**NEW CONSTRUCTION AND DEMOLITION OF EXISTING BUILDINGS
259 AND 275 WOODBRIDGE AVENUE AND 64 ABELL AVENUE
WOODBIDGE HERITAGE CONSERVATION DISTRICT
WARD 2 - VICINITY OF WOODBRIDGE AVENUE AND KIPLING AVENUE**

The purpose of this report is to seek Heritage Vaughan approval of the recommendations to Council for the proposed demolition of existing buildings and the proposed new construction of a multi-storey building at 259 and 275 Woodbridge Avenue and 64 Abell Avenue located within the Woodbridge Heritage Conservation District (HCD).

RE: HERITAGE CONSERVATION DISTRICT CONFORMITY REPORT
259/275 Woodbridge Ave., and 64 Abell Avenue, Part Lot 7, Concession 7.

SITE PLAN **1**
Scale: 1 : 250 **A1-1**

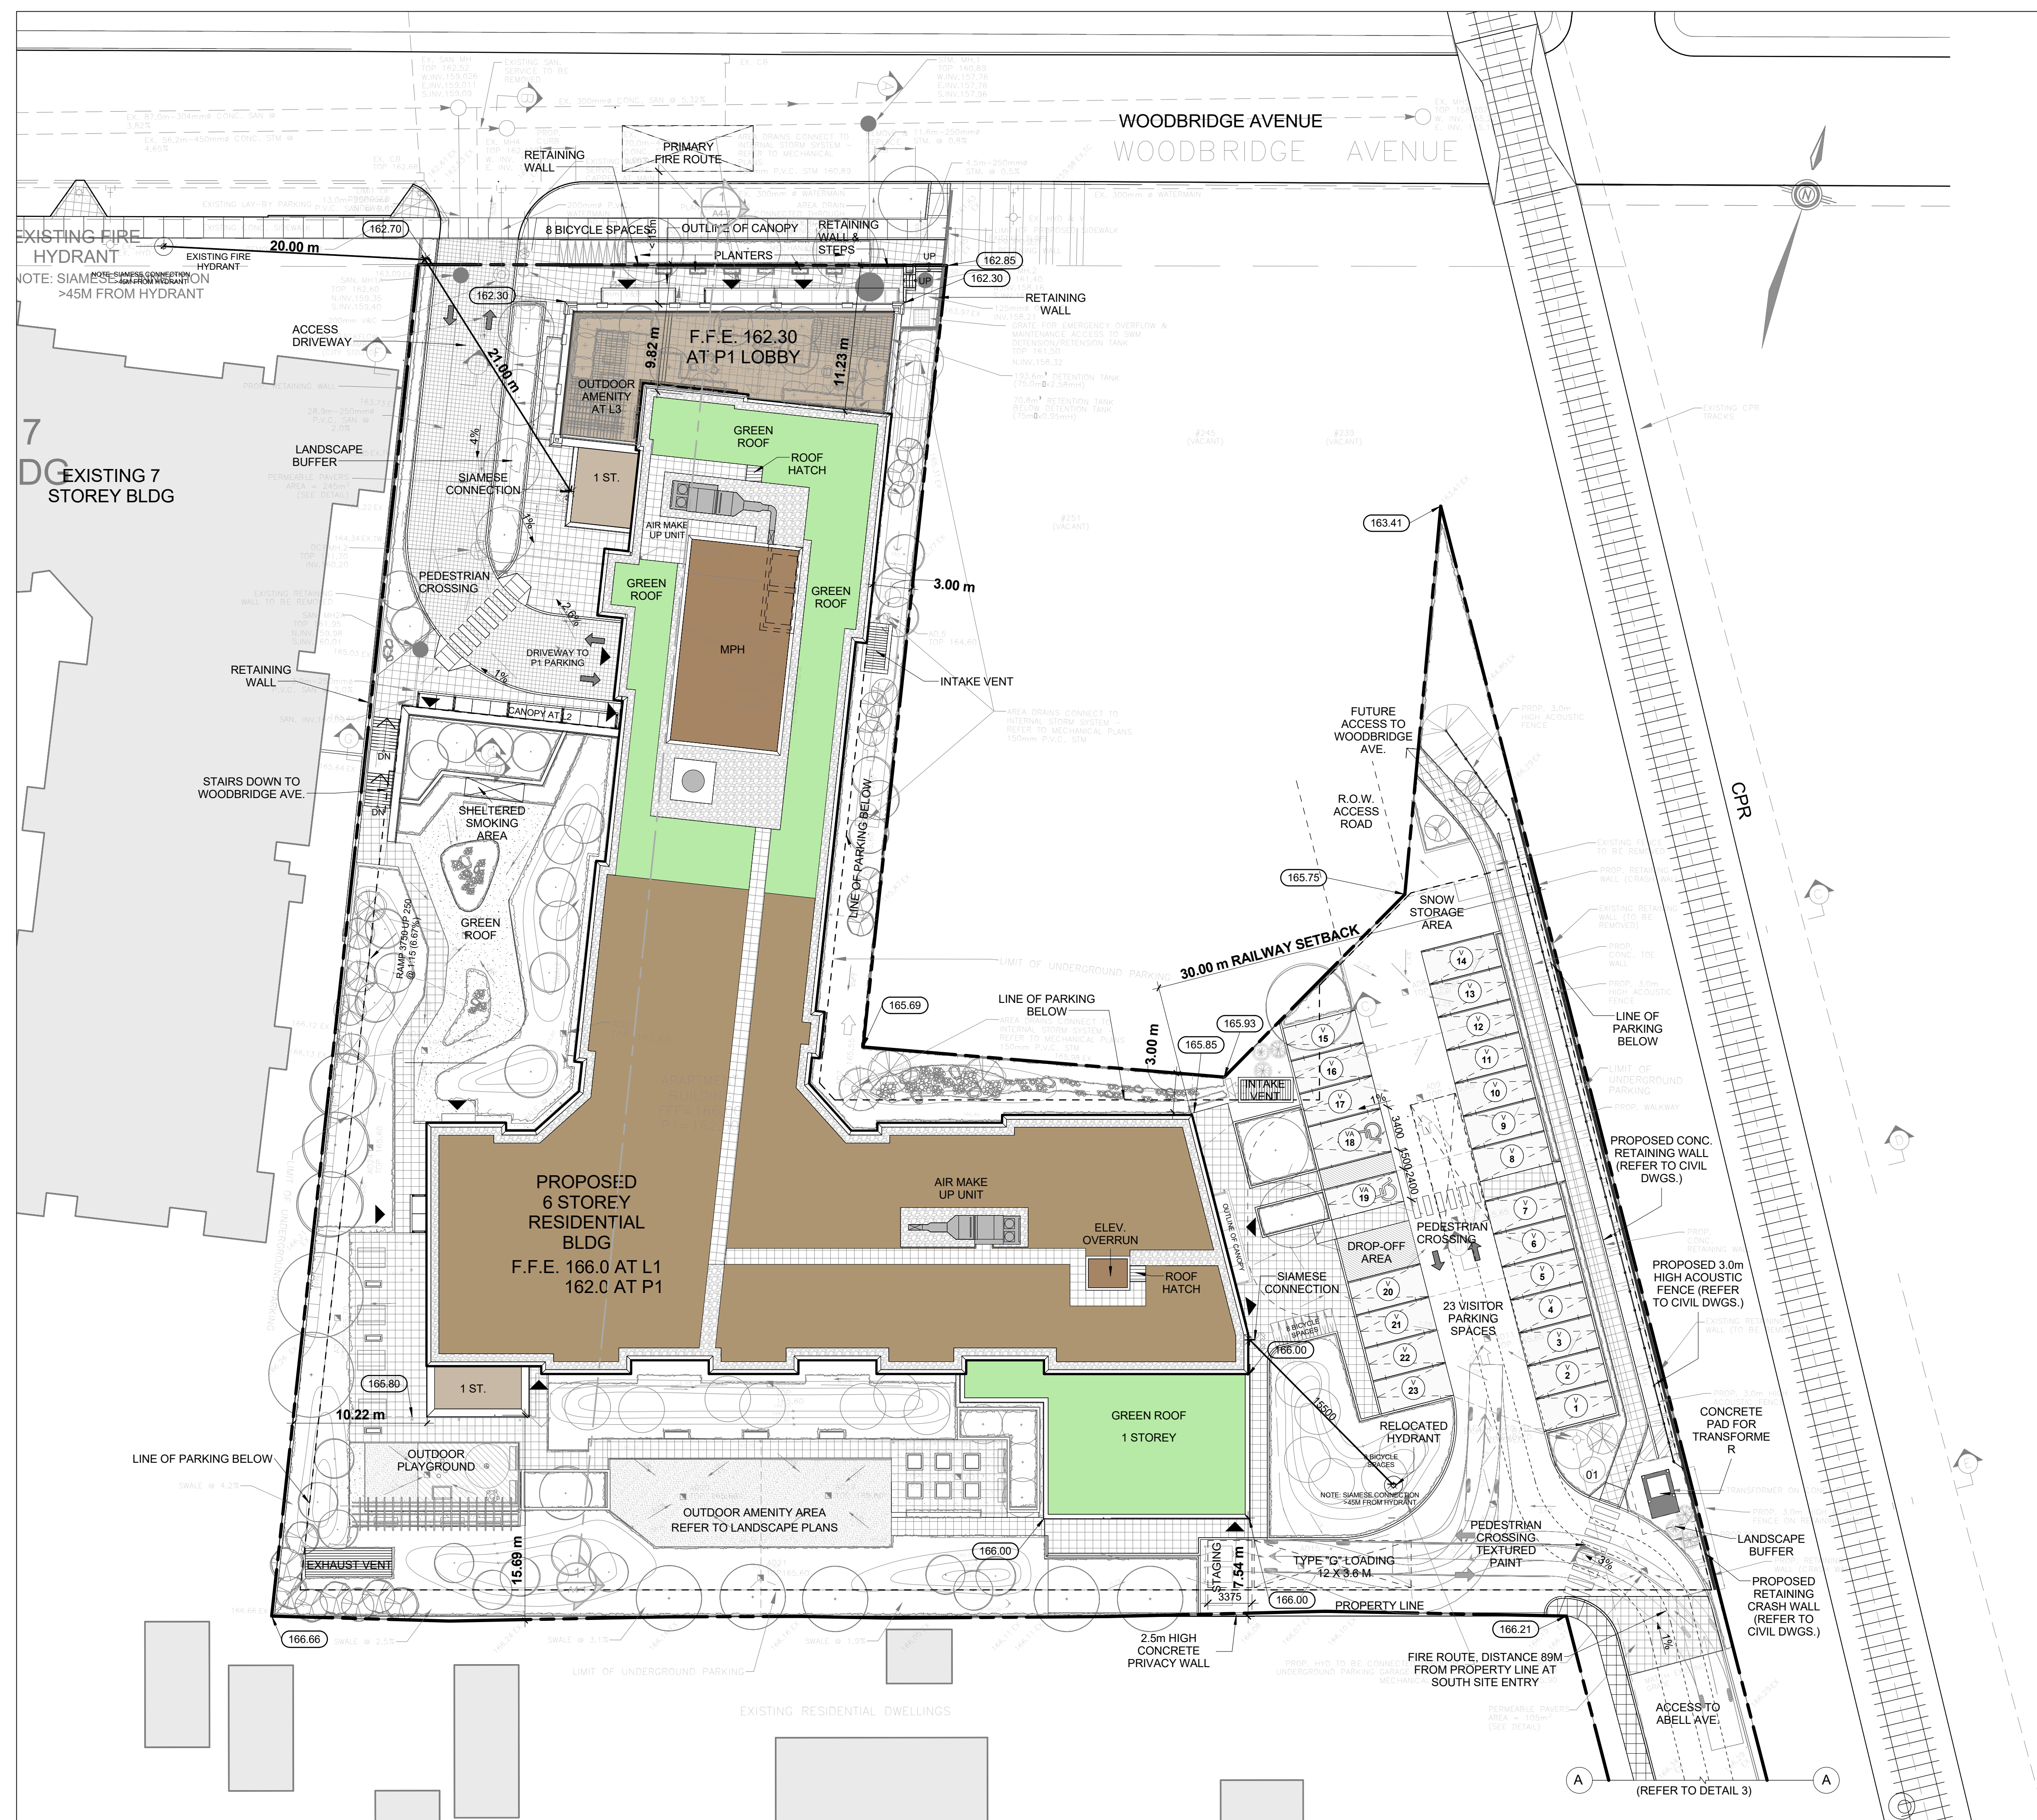
Comment: Woodbridge Avenue is the commercial centre of the Woodbridge Heritage Conservation District and a pedestrian-oriented main street. The proposed building has uses and entrances that are grade-related and open onto Woodbridge Avenue with a proposed setback of 3m to allow for spill-out activities. Access to the underground parking from Woodbridge Avenue is at the west side of the site and is concealed and buffered with landscape treatment. The majority of pick up and drop off is at the Abell Avenue access and surface parking at the Abell Avenue access will be screened with planting.

ELEVATIONS

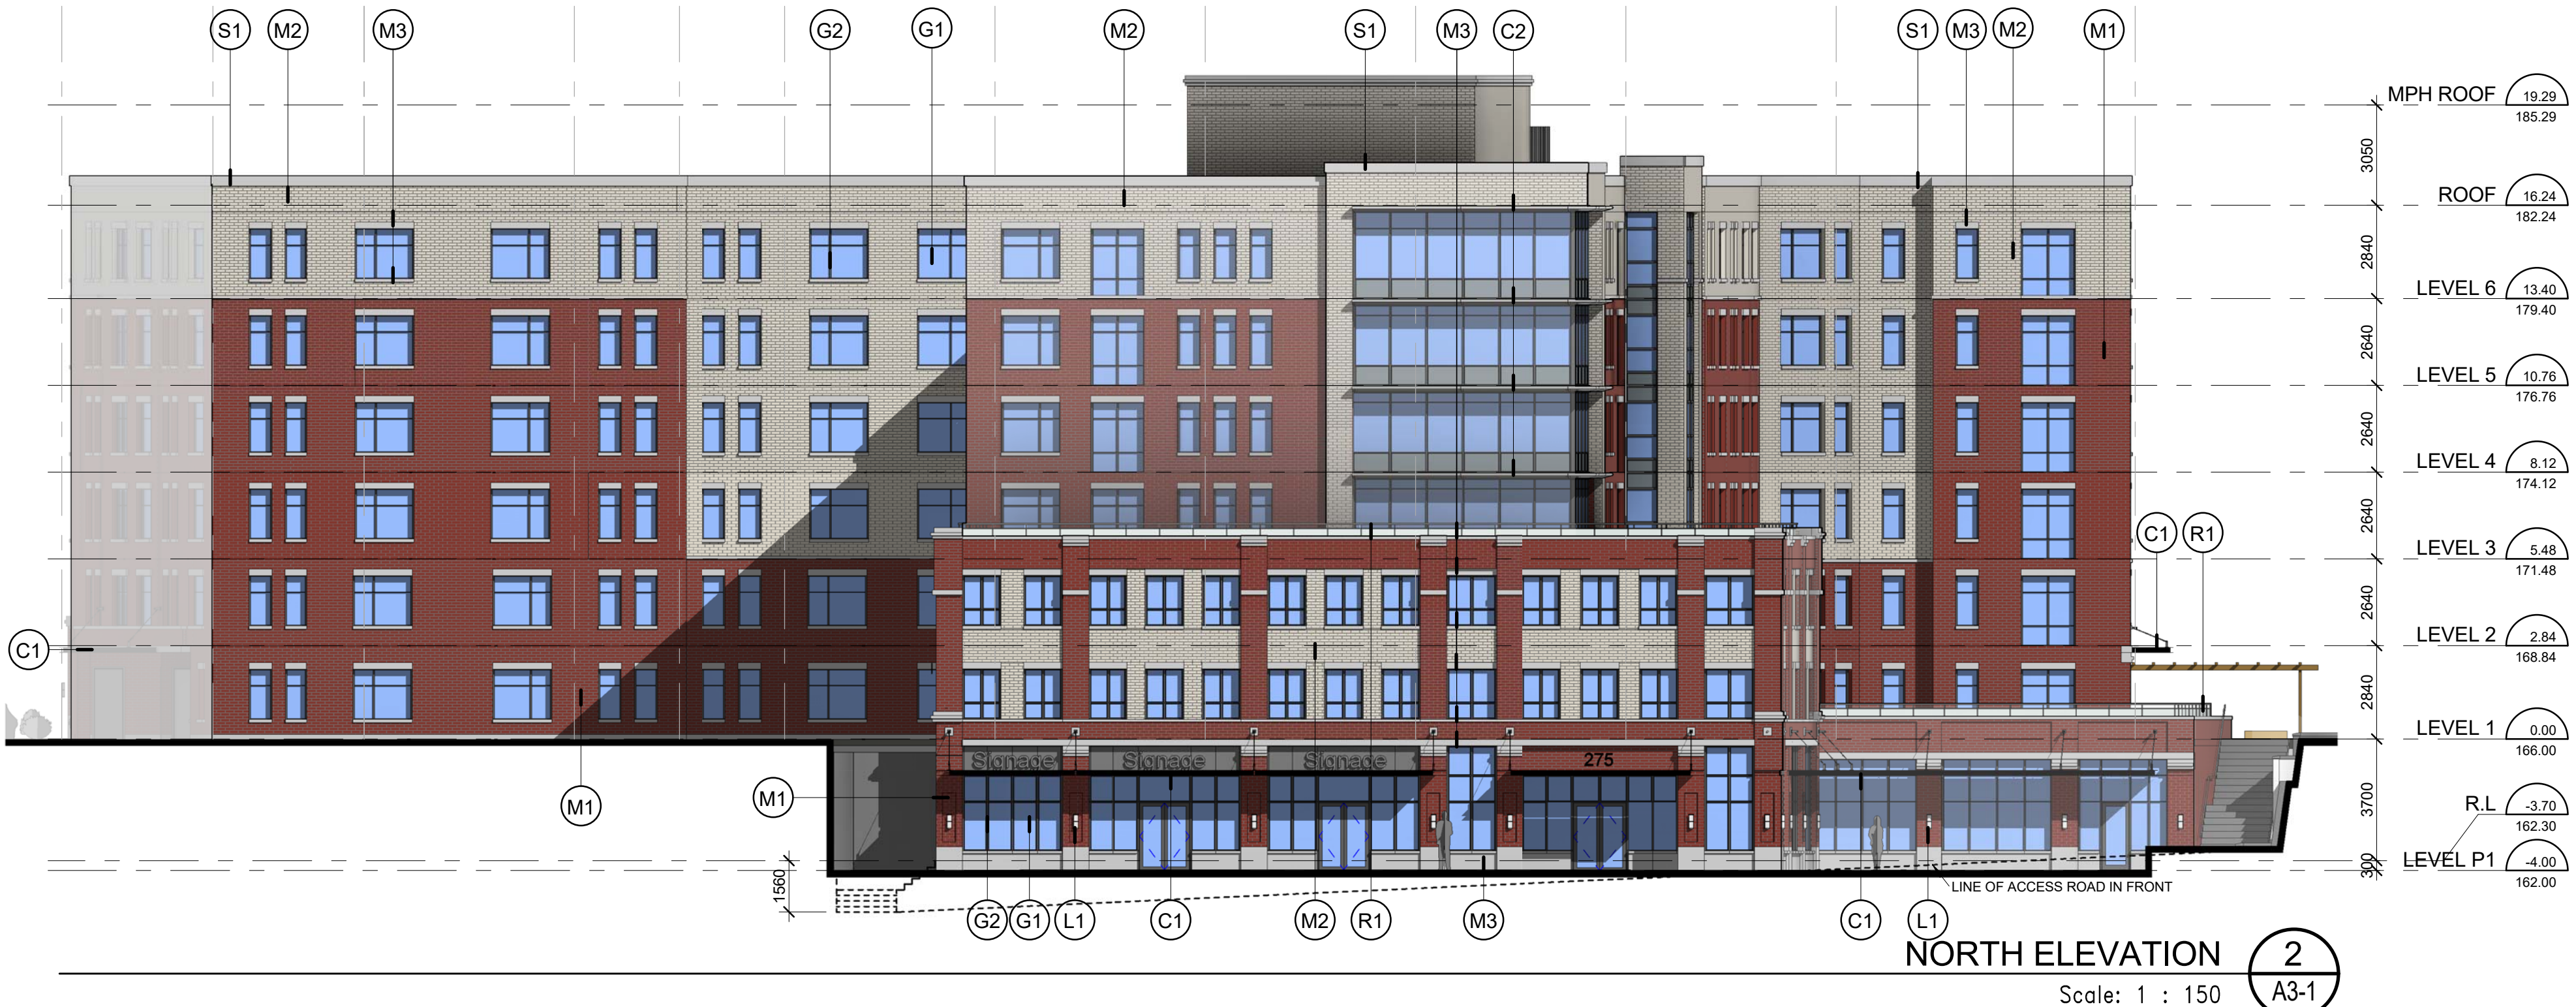
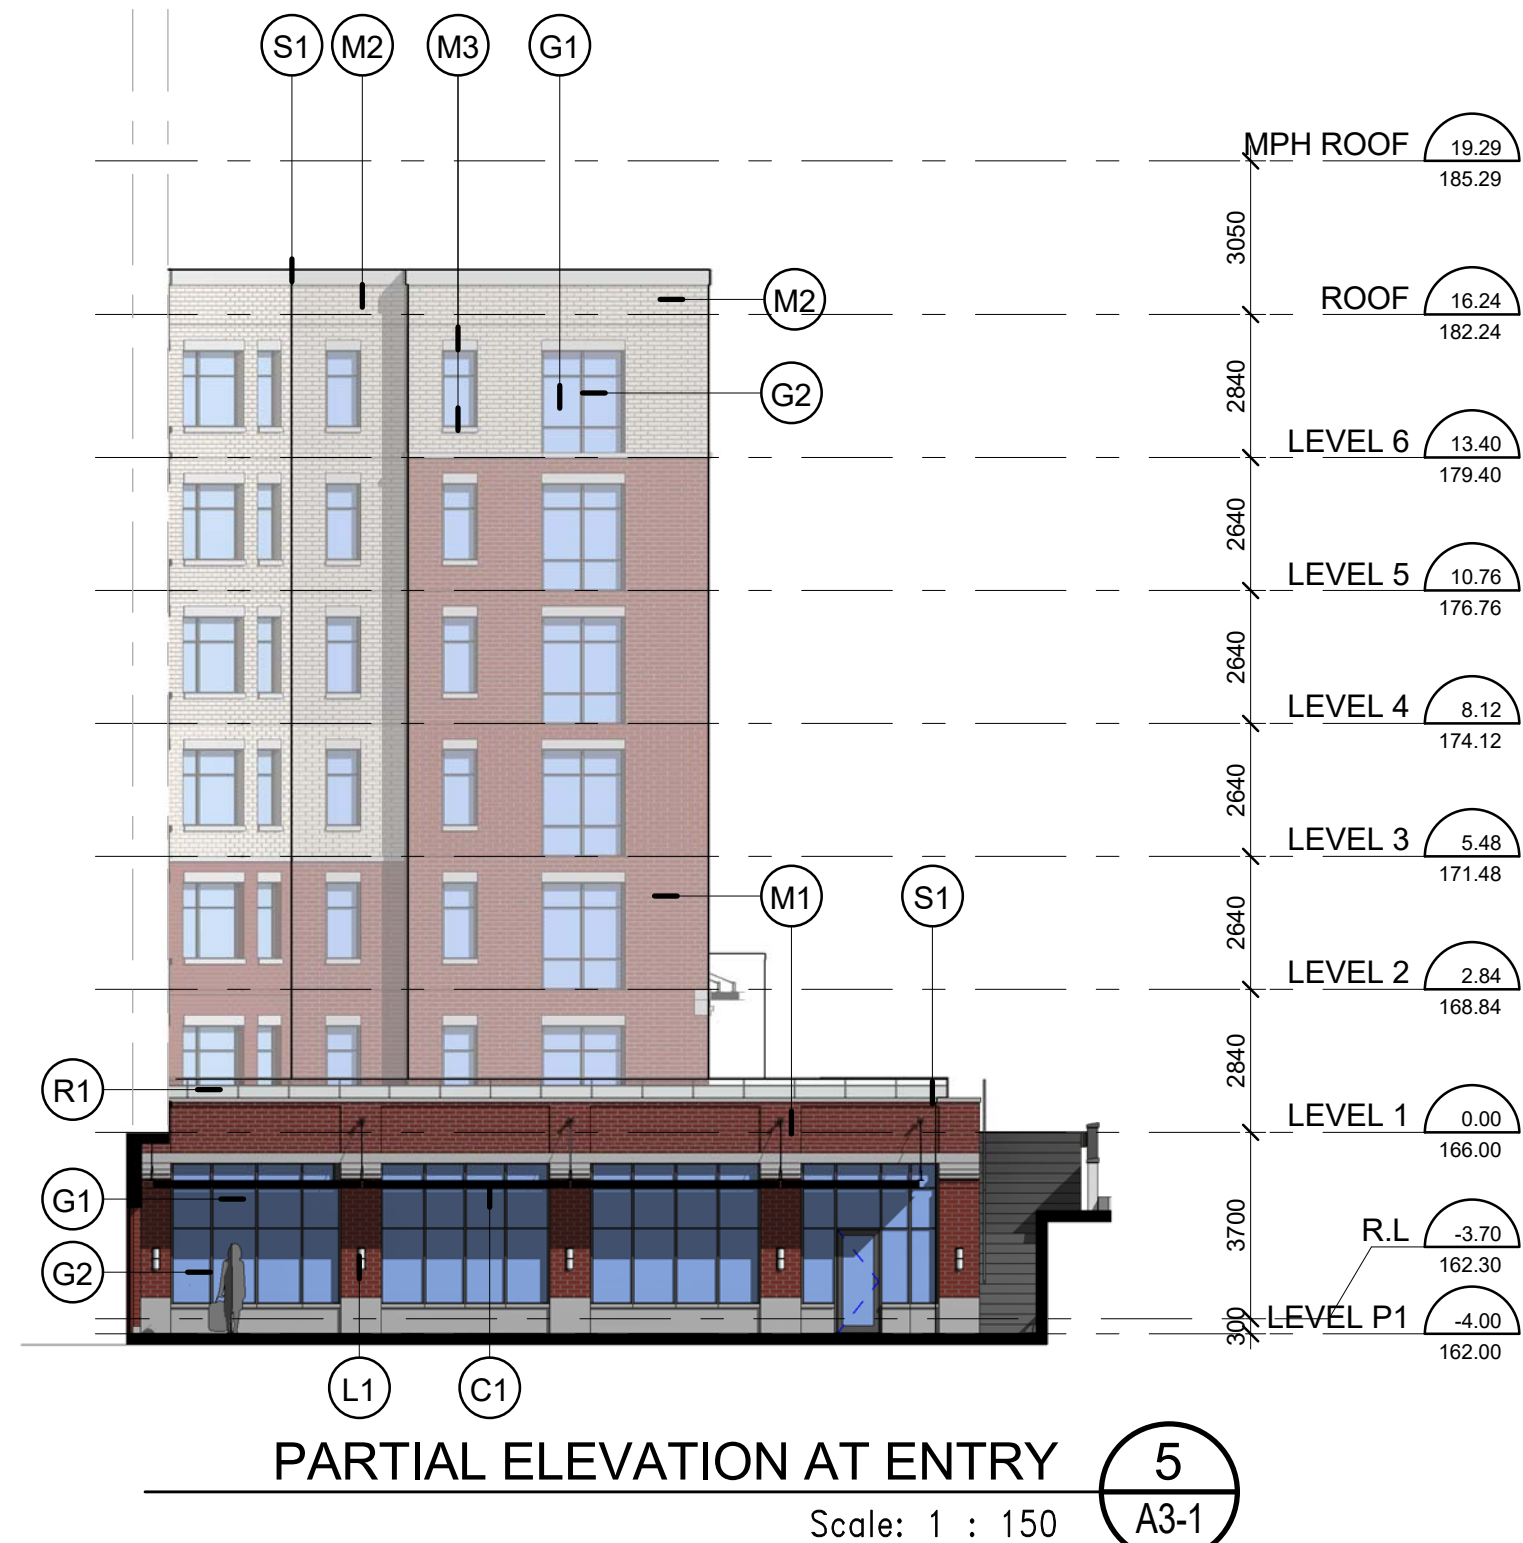
- Red brick masonry has been introduced throughout the higher levels of the rear of the building to give the building a residential appearance
- The parapet has been more clearly defined and articulated

Comment: The proposed development includes a 3 storey commercial and residential podium that incorporates traditional commercial elements – fascia signage, symmetrical storefronts, and pilasters – while still achieving a contemporary look. The proposed podium also contains a clearly defined base, body, and cap which is typical of historical commercial development. The Woodbridge HCD Plan encourages new development that is “of its time” but not overly pastiche or carbon copies of historical styles.

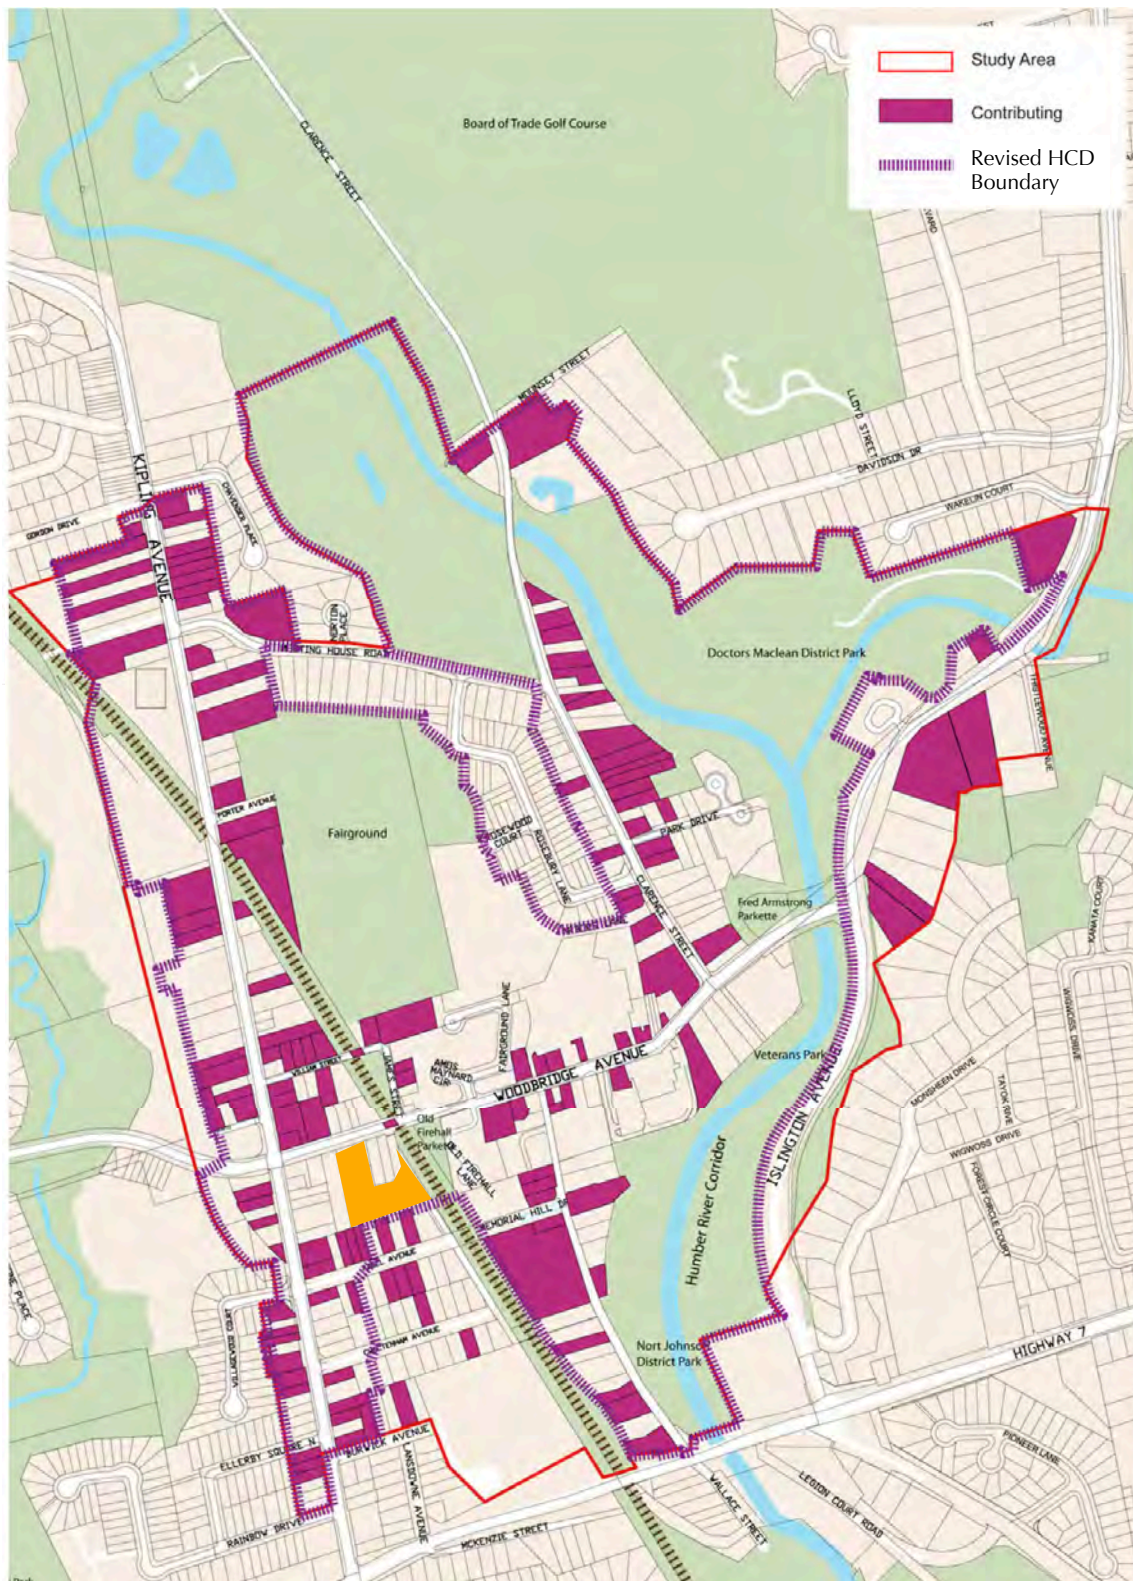
The proposed project is to be located within the boundaries of the Woodbridge HCD. A plan of this district is included on the following page. The HCD Plan has a number of stipulations with respect to new development or renovations of existing streetscapes and these are evaluated in this current letter.
